MY GARAGE @ NORTHCREST

RECORD DRAWINGS

Grading Erosion Control Plan

My Garage @ Northcrest
Site Detail Plan - Record Drawings

C303

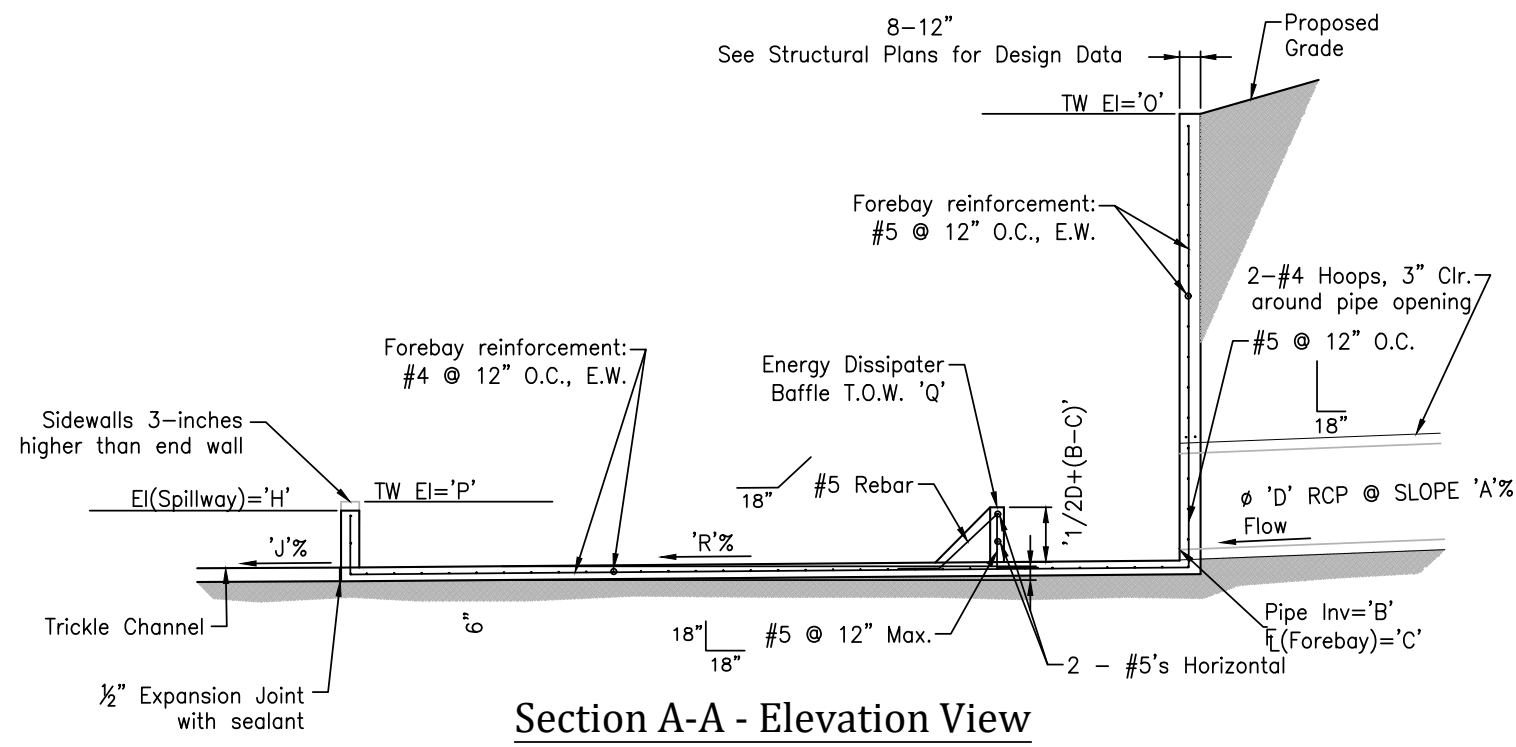
PA Punchlist Item:
"Trapezoidal swale. Plans call for grass lined swale. Contractor is wanting to install riprap swale."

As-Built comment: please shoot me an email if the contractor decided to leave this as grass lined. Otherwise redline this as riprap if that's what the contractor did in the field. We'll also need calcs to show that the riprap is sufficiently sized for the flows.

C602

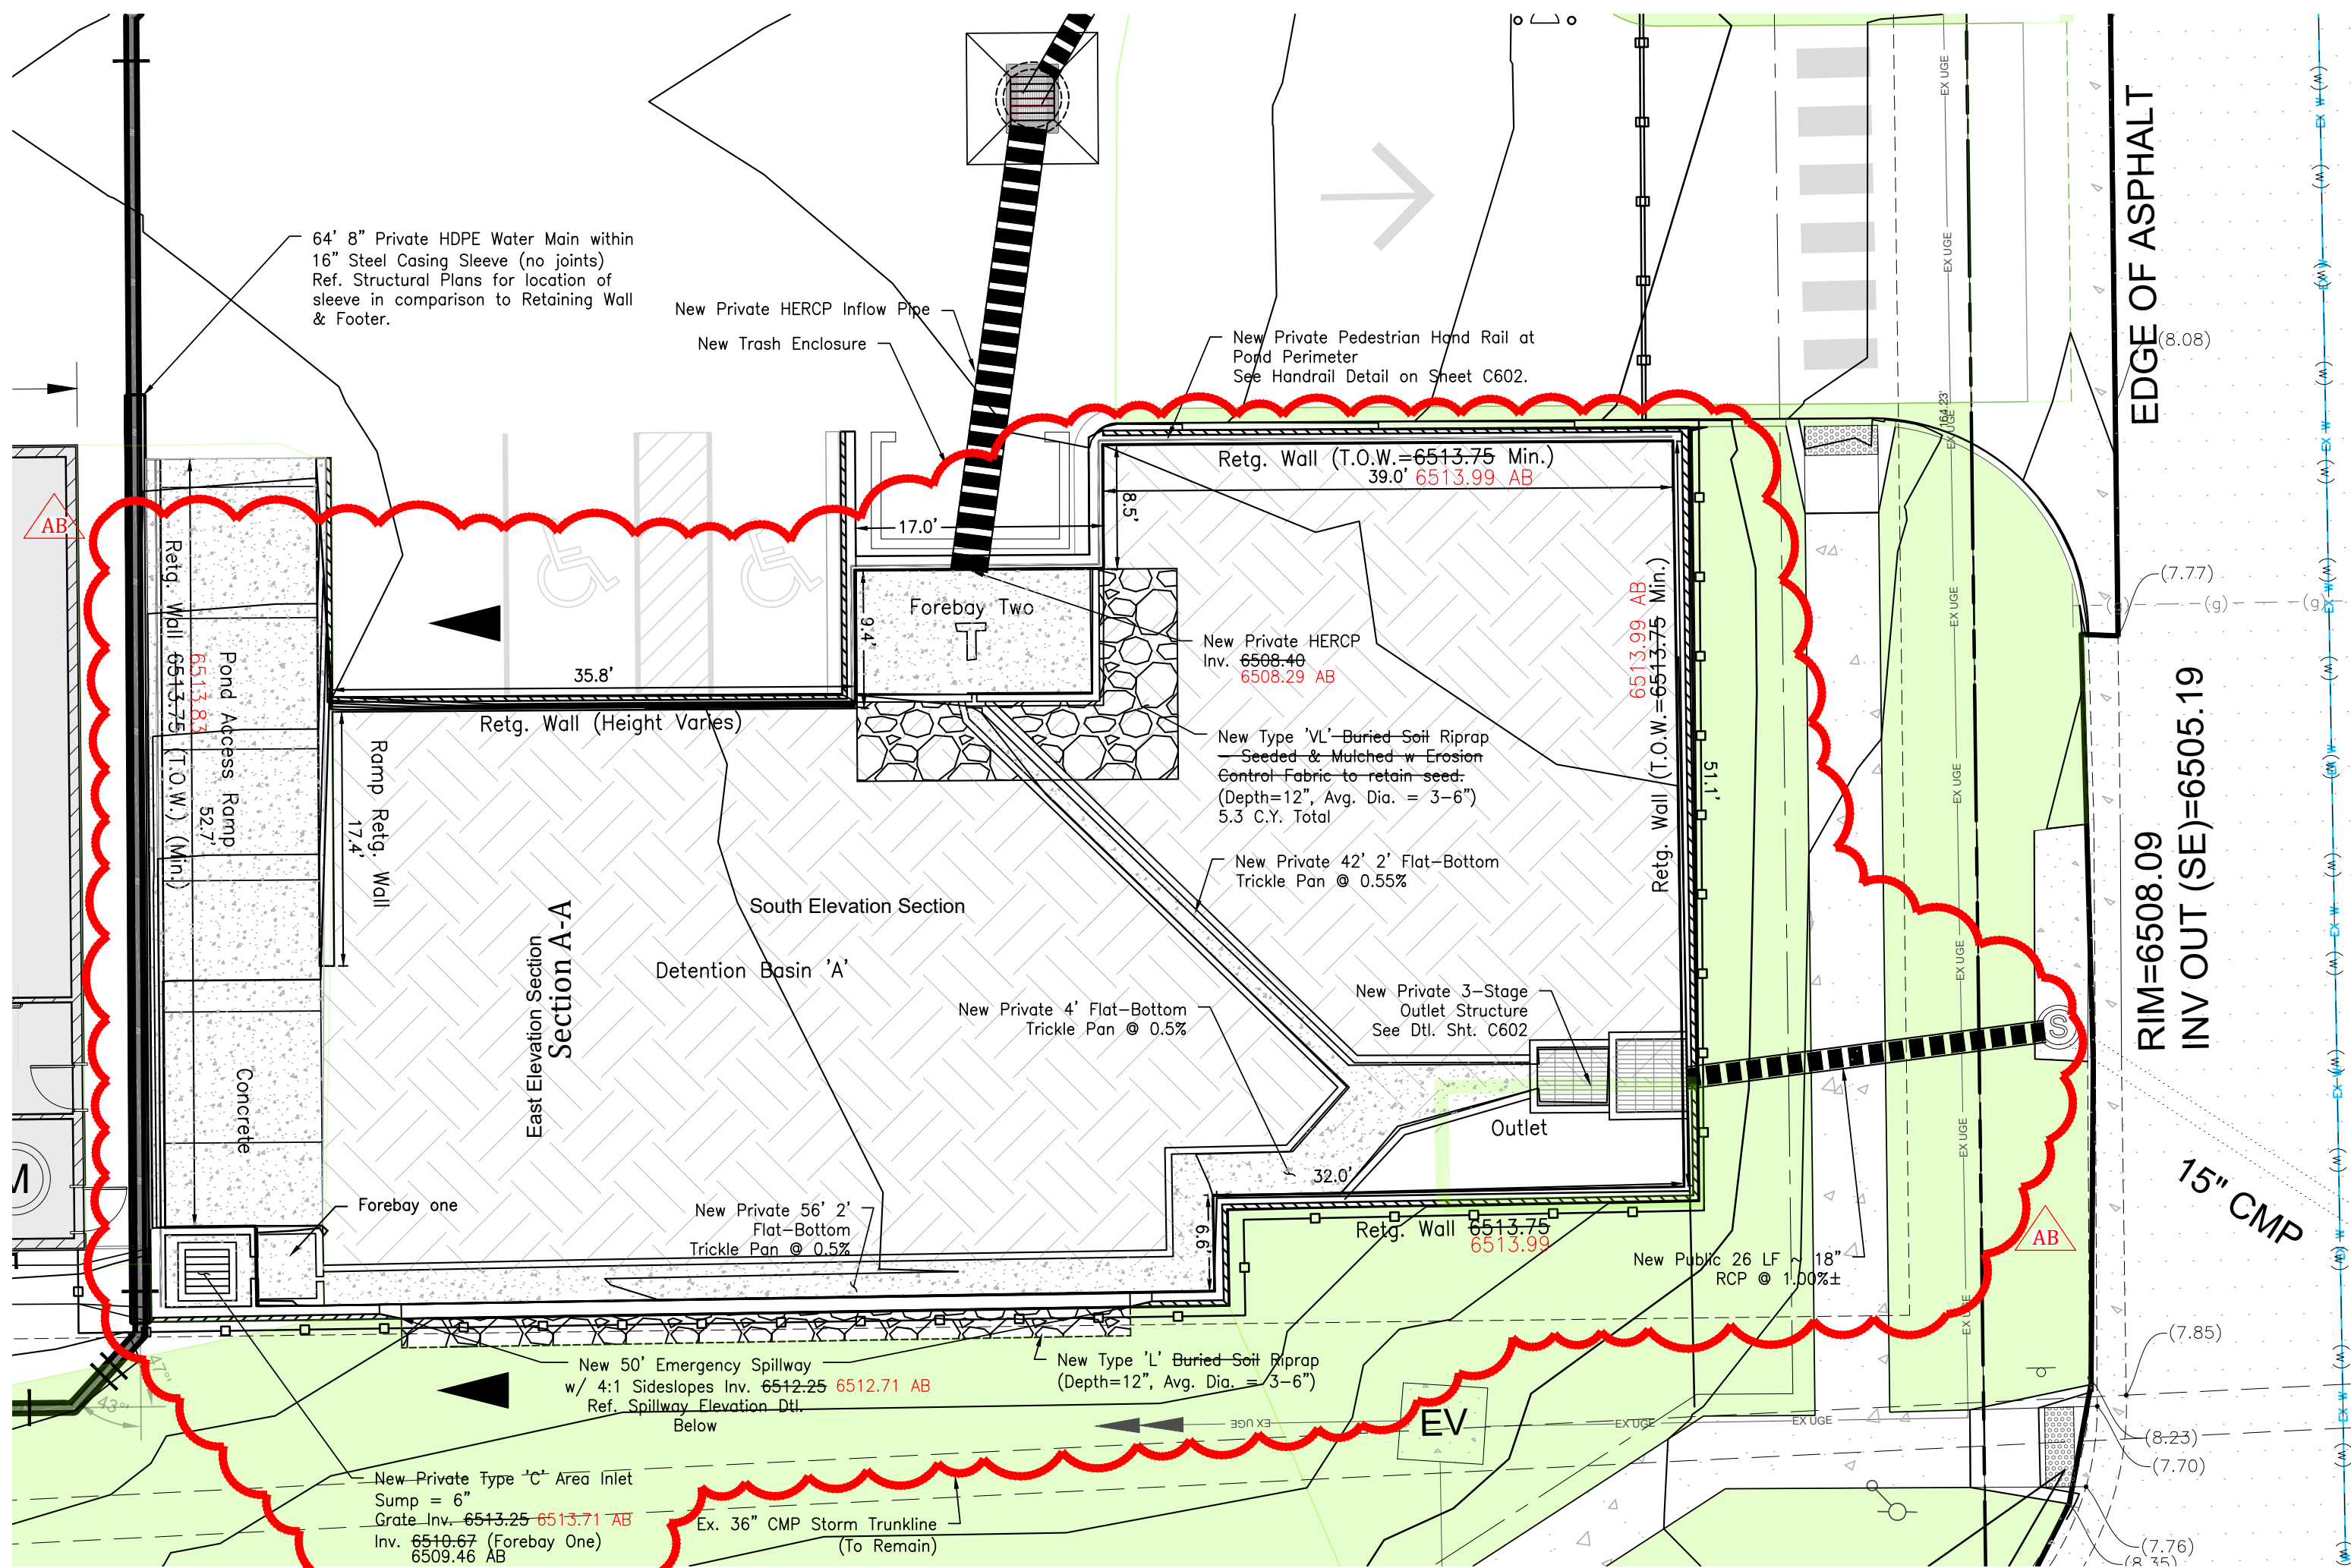
To Ed's point with his comment on page 1 above, the whole point of as-builts is for engineers to certify that they have walked/surveyed the site and are confirming the subsequent redlines on these plans. This is similar to how an engineer signs/stamps the CDs pre-construction without this type of disclaimer, even though they may be relying on topo from a surveyor, shop drawings from a sub-contractor, etc.

2 Outlet Structure Detail
C602 NOT TO SCALE

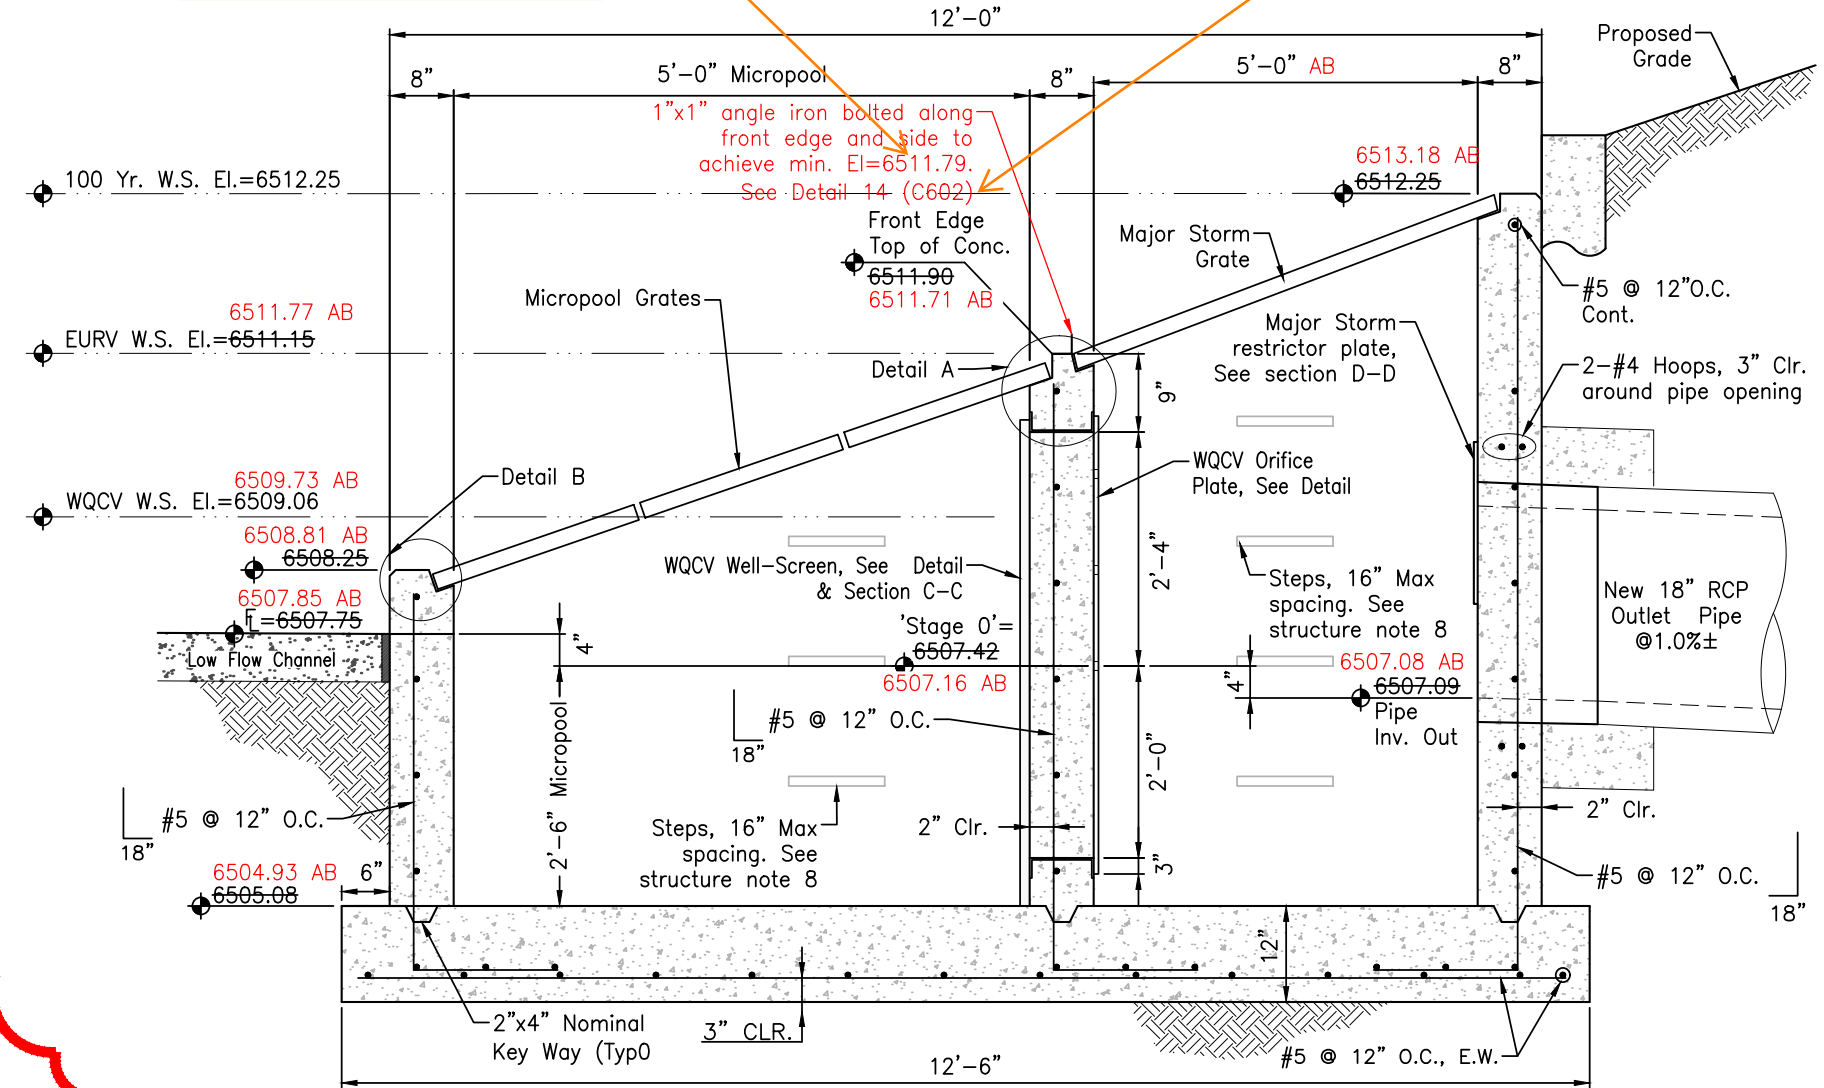
Calcs show this at:
6507.16 + 4.55 = 6511.71
Or did you mean to input 4.63 into Overflow Weir Front Edge Height on the calcs?
